Preliminary Plan

Sanctuary Court

Hinckley Township

Meeting:	June 5, 2024	**Sublots:**	15
App. No.:	031-2024 PP	**Zoning:**	R-1 Single-Family Residential
Owner:	303 Development LLC	**Utilities:**	Central Sewer and Water
Engineer:	Davey Resource Group	**School Dist.:**	Highland Local
Parcel No.:	016-03C-03-039	**Reviewer:**	Denise Testa
Site Area:	37.9105 acres

SITE PLAN

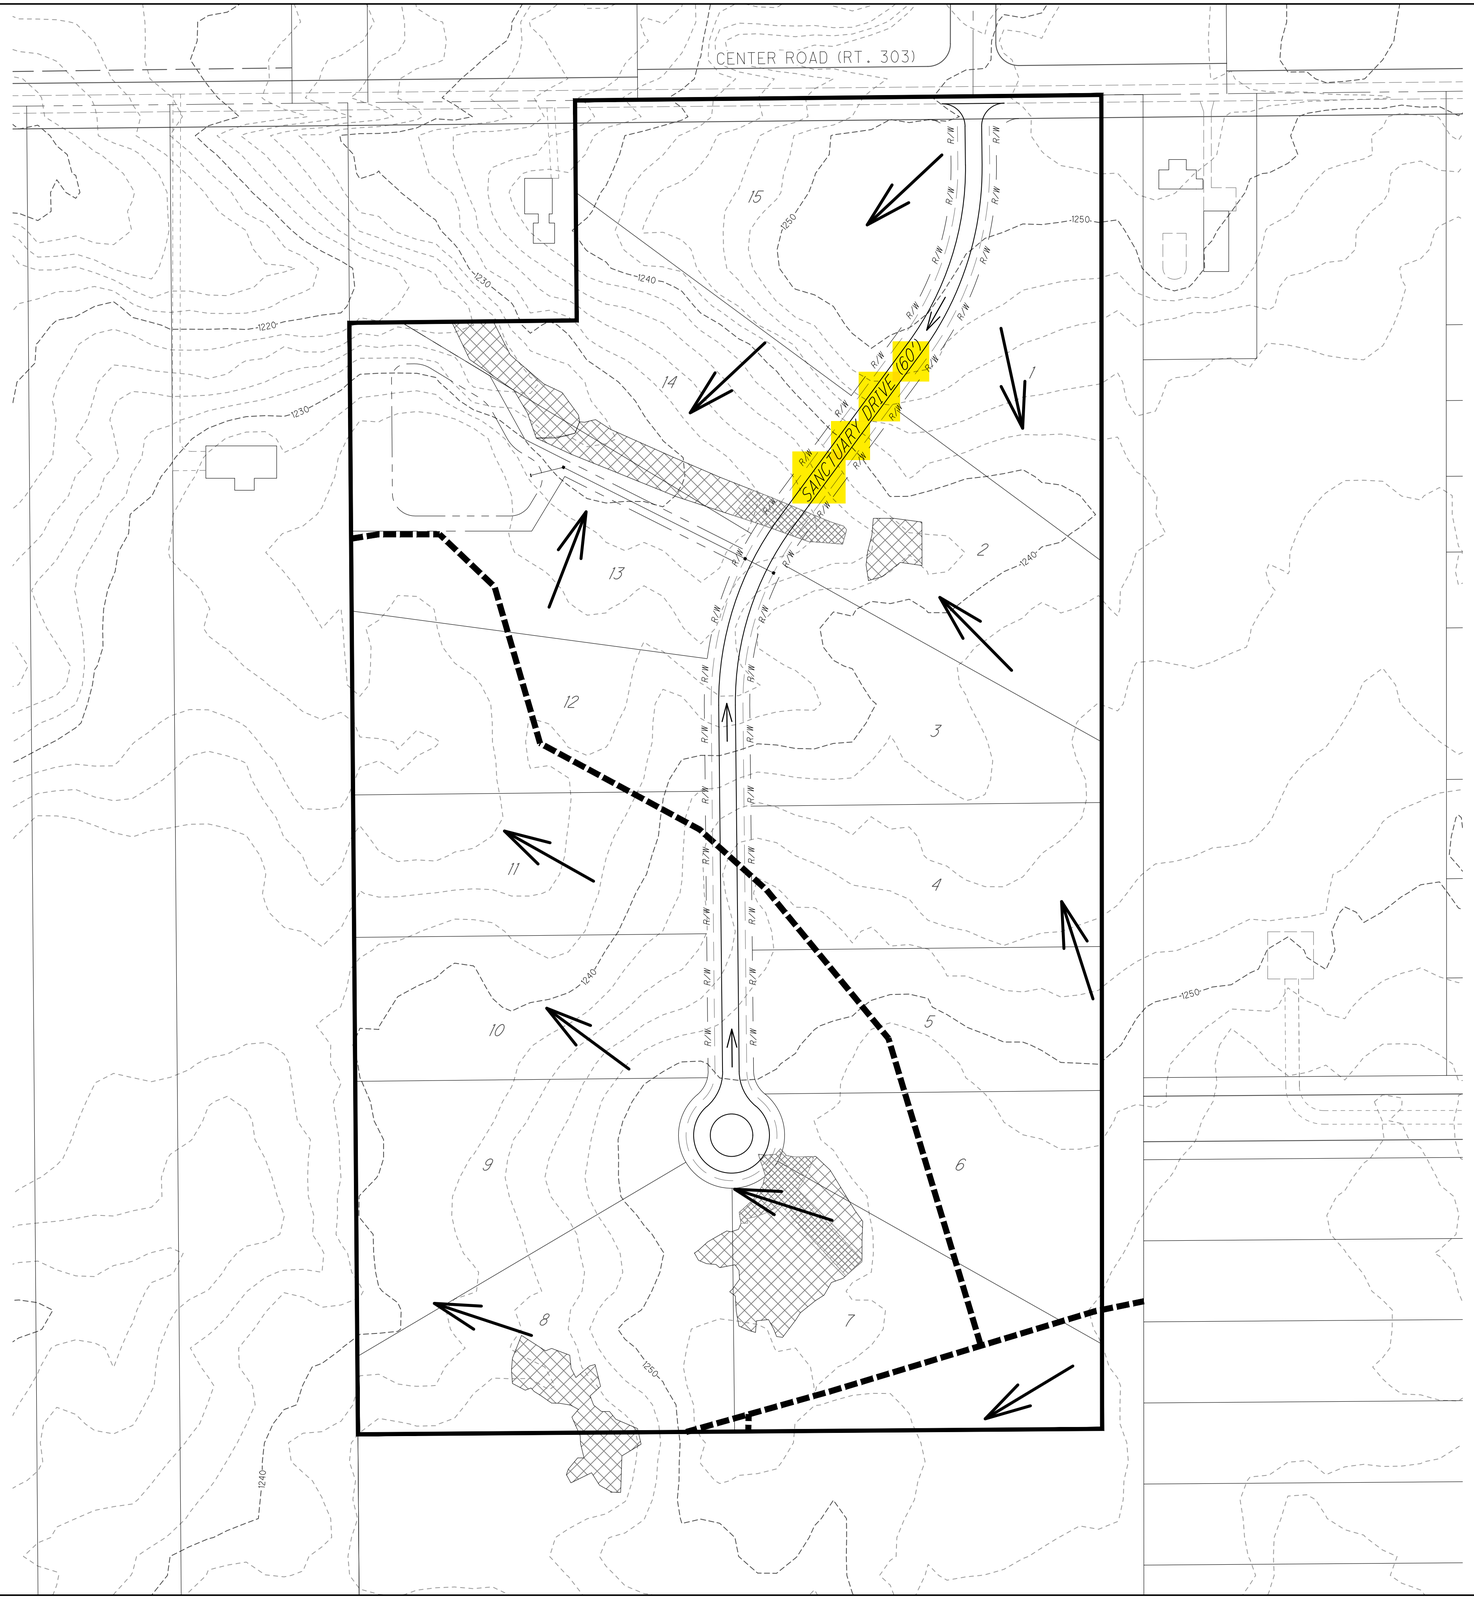
Review completed by JW 04/30/2024

See page 1 regarding state acceptance of dedicated ROW

will this be a block or part of the dedicated ROW?
